EEG-33  
DOE/AL/10752-33

## ADEQUACY OF TRUPACT-I DESIGN FOR TRANSPORTING CONTACT-HANDLED TRANSURANIC WASTES TO WIPP

James K. Channell, John C. Rodgers, and Robert H. Neill

June 1986

Figure 2. TRUPACT-I transport package.

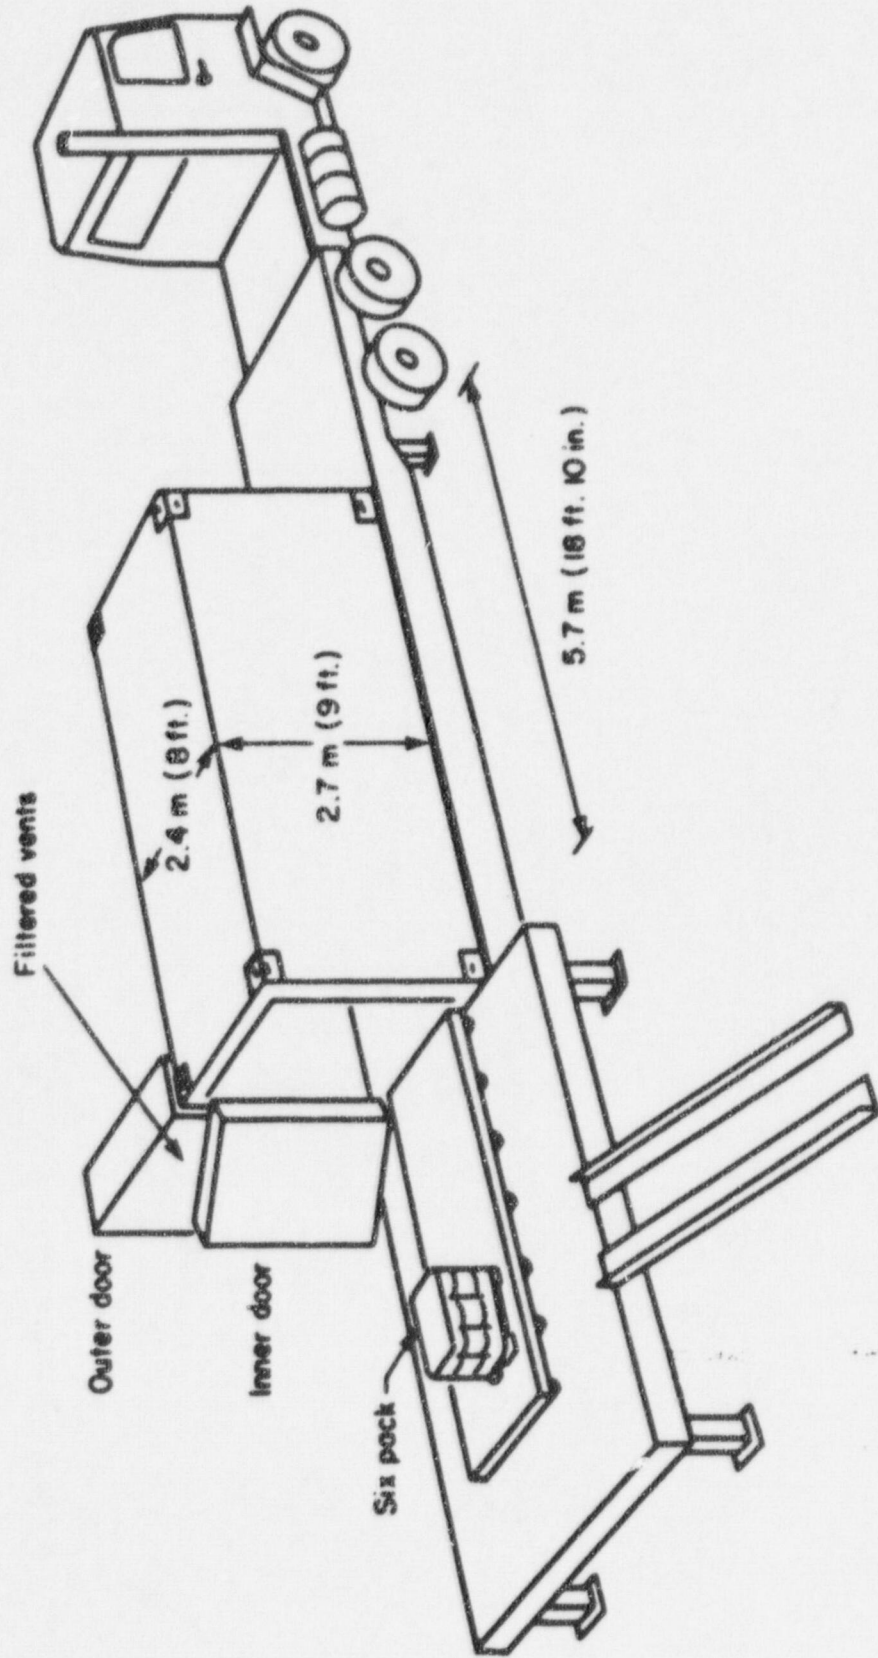
The Department of Energy (DOE) has developed a Type B packaging system known as the TRUPACT (Transuranic Waste Package Transporter) to transport the TRU waste to WIPP. The present 36 drum design (TRUPACT-I) will require about 24,000 shipments over a 20 year period beginning October 1988. The relative fraction to be shipped via truck and railroad has not been determined. Figure 1 shows the generation and storage sites of the TRU wastes that will be transported to WIPP via truck or rail. Figure 2 shows a schematic diagram of the TRUPACT.

The TRUPACT was designed in 1978 for single containment (Ref 5). Federal regulations in existence at that time, as well as today, required a double containment design (Ref 6 and 7) for shipments in excess of 20 curies of plutonium. Most of the shipments to WIPP will have more than 20 curies of plutonium.

Figure 10. Filter vent concepts.

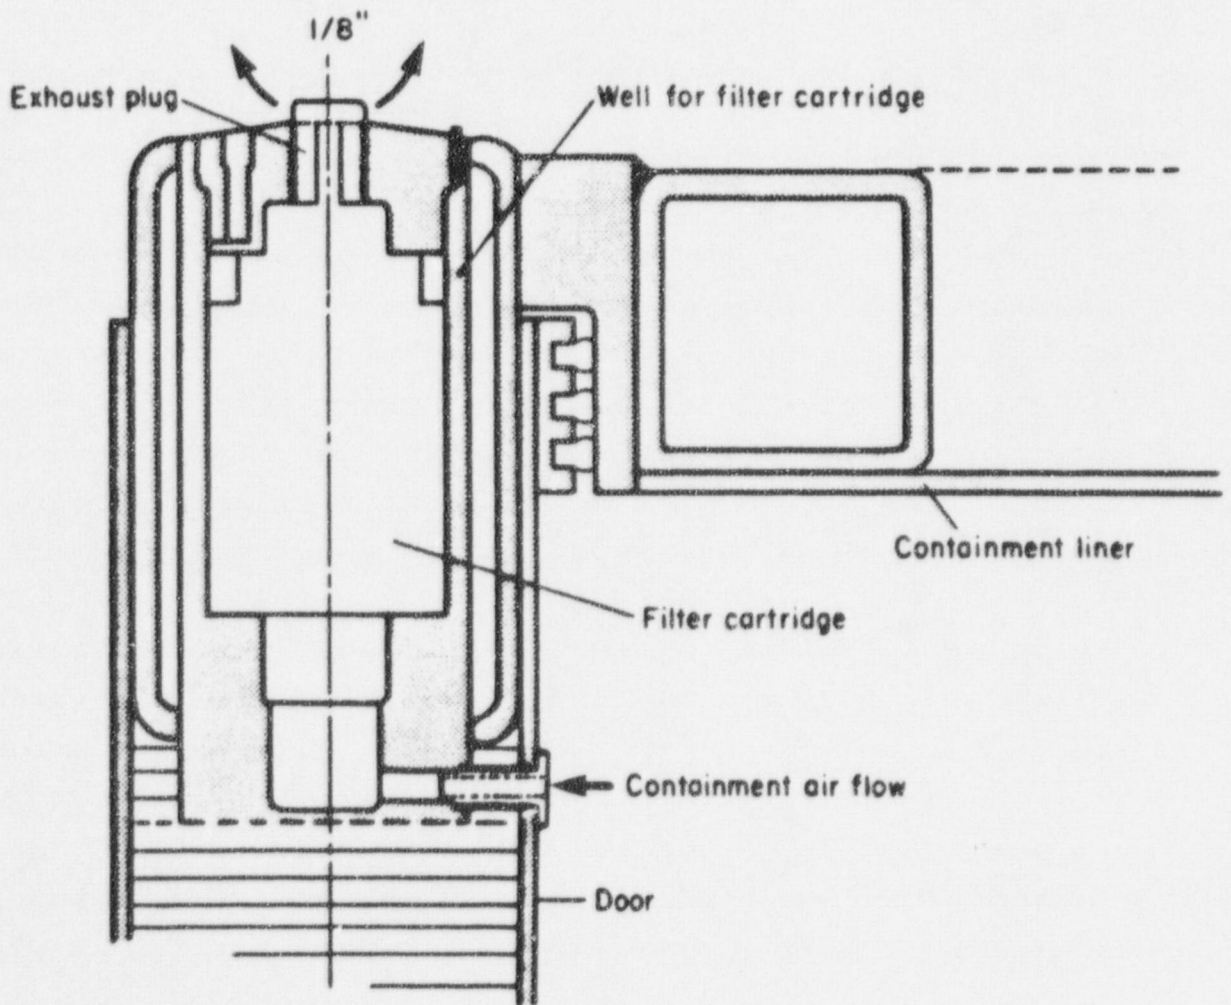
The third option, venting, has received the most attention by DOE. The concept which has been most thoroughly investigated involves venting the waste packages through rugged high efficiency filters or permeable gaskets and vent clips so that gases are released. Particulates are supposed to be retained in the containers even under severe transport conditions. Figure 10 (a) illustrates the small filter (RFP bung filter) being considered by DOE for Type A packages, and 10 (b) the filter design which has been proposed for the TRUPACT (if it is vented). The prime consideration is whether venting will provide the needed control of hydrogen concentrations in Type A packages and the Type B TRUPACT under the actual transport conditions of the waste forms and TRU concentrations anticipated

A. ROCKY FLATS PLANT SMALL BUNG FILTER CONCEPT  
HOLE AREA = 0.079 cm<sup>2</sup>  
EFF. THICKNESS = 13.24 cm

B. TRUPACT I PROPOSED FILTER

Figure 14. Vented TRUPACT with 36 drums (20 Ci/drum).

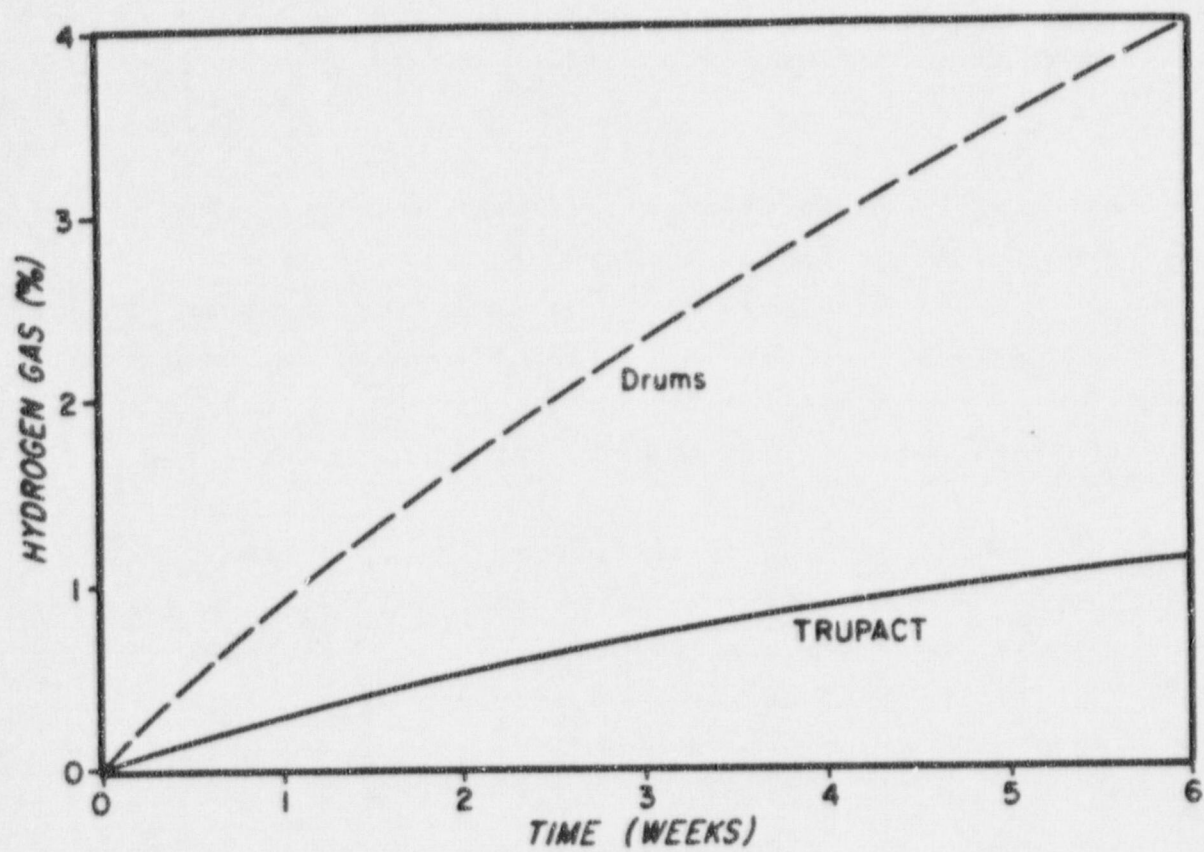
By modeling, we have attempted to examine the predicted efficacy of venting. If the case of dry combustibles where  $G$  (hydrogen) = 2.1 is extended to the maximum controllable loading by the Clements and Kudera method, the allowable loading would be 20 curies and the 4% limit would be exceeded in about 3 weeks. Furthermore, if 36 of these drums were loaded into a vented TRUPACT, concentrations would reach 4% hydrogen in 6 weeks. (See Figure 14).

Our perception of the venting process at this time is that during the initial post-closure period following purging, the relatively rapid buildup of hydrogen concentration either due to high initial  $G$ (hydrogen) or the presence of hydrogen in sealed packages diffusing into the void, or both, quickly displaces air from the void space without a large loss of hydrogen, since the initial hydrogen concentration gradients are small. But then as the hydrogen concentration builds, even though the hydrogen contributions from various sources may drop to modest levels, the hydrogen concentration can rise to the flammable or explosive limit if the curie level is high enough. A critical factor in the process just outlined is the occurrence of an initial high influx of hydrogen, even for a few hours or days.

results, we conclude that venting of the Type A and Type B (TRUPACT) waste packages to achieve hydrogen control is not likely to result in the desired effect for a significant portion of the present defense TRU inventory and thus should not be relied upon as a control mechanism, particularly if a relatively inexpensive and effective alternative control practice is available.

Figure 16. Effects of getter on hydrogen concentration in drums.

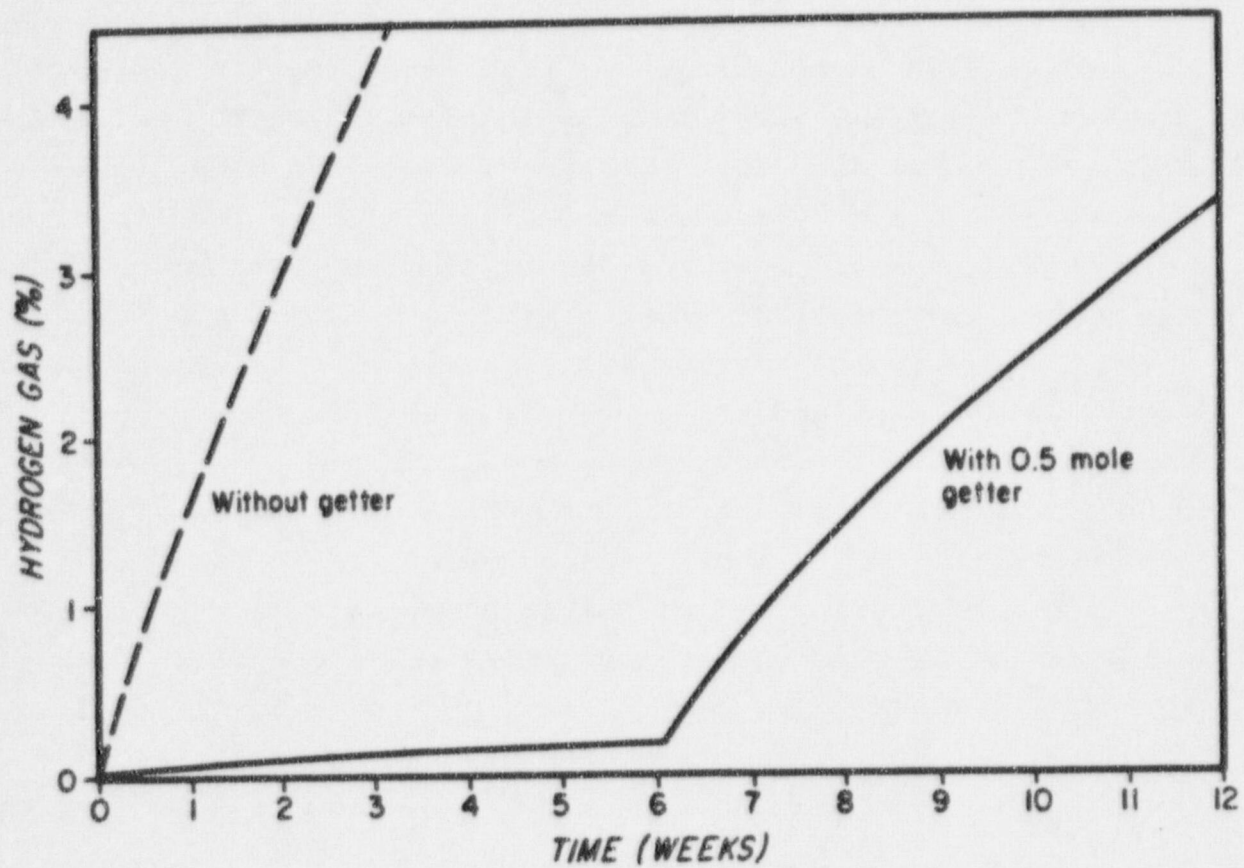
If the removal process is limited primarily by diffusion of hydrogen to the active surface, effective control can be anticipated by placing a hydrogen getter (Fig 15) in the drum. It may be possible to spray getter material in sufficient quantity on the inner surface of Type A packages to effectively control hydrogen for the handling and shipping period. A computer model simulation of such a process is shown in Figure 16. A simple representation of the removal by gettering was assumed with only a limited number of sites available (0.5 hydrogen moles equivalent). Without the use of getters, a

flammable level of hydrogen is reached in less than 3 weeks. However, with getters, an additional 3 weeks of very low hydrogen concentrations are realized before the getter is consumed, and several more weeks during which ingrowing hydrogen concentrations are still below four percent.

An added advantage of placing the getter or recombiner materials in the Type A package instead of the TRUPACT is that model simulations indicate that where the TRUPACT is sealed, but the drums are vented, flammable mixtures can accumulate in the drums even though the TRUPACT void levels are acceptably low. If the getter is placed in the Type A packages also, control of both containers is achieved, which should be the only acceptable condition for transport and receipt at WIPP.
